REGIONAL REVIEW NOTICE

ARC REVIEW CODE: R1210101

Name of Proposal: Peak at University Parkway

Description: The proposed Peak at University Parkway, located in the City of Dacula, is a proposed mixed use development on 157 acres that will include 2.5 million square feet of commercial, office, industrial, and retail spaces, hotels, and 613 residential units. The proposed development is located on the northeastern quadrant of the Winder Highway (SR 8) and University Parkway (SR 316).

Land Use Plan

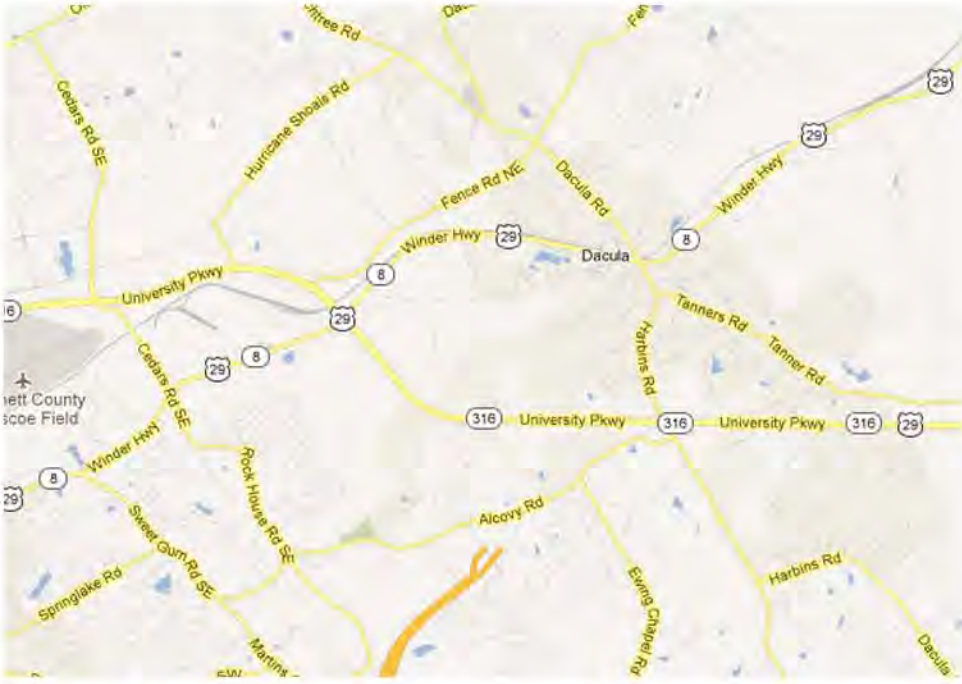
The proposed Peak at University Parkway development includes several good site design characteristics including the creation of a mixed use environment, facing buildings onto public streets, placing parking behind or to the side of buildings, creation of “urban blocks” within the site, the inclusion of useable greenspace, and the creation of a parkway that connects through the site which includes sidewalks and on-street parking.

The applicant is proposing to provide more parking than is required by the City of Dacula’s zoning ordinance. The proposal will include 9,563 parking spaces while the City only requires 6,594 spaces.

If the developer wants to build more parking than required by local regulations, shared parking or pervious materials should be used to limit the amount of impervious areas and reduce storm water runoff from the parking areas.

There may be additional opportunities to provide “stub-outs” for future connects to adjacent properties. Although most of the adjoining properties around this development are undeveloped, providing potential connections will encourage better connectivity as the area develops and provide additional access to and from the site. Additionally, the developer should investigate better connections between the residential portion of the site and the rest of the development.

The proposed project site plan shows buffers along both streams. While the buffer depths are not specified, they appear to be about 75 feet deep along both streams. No intrusions other than road crossings are shown on the proposed project plans.
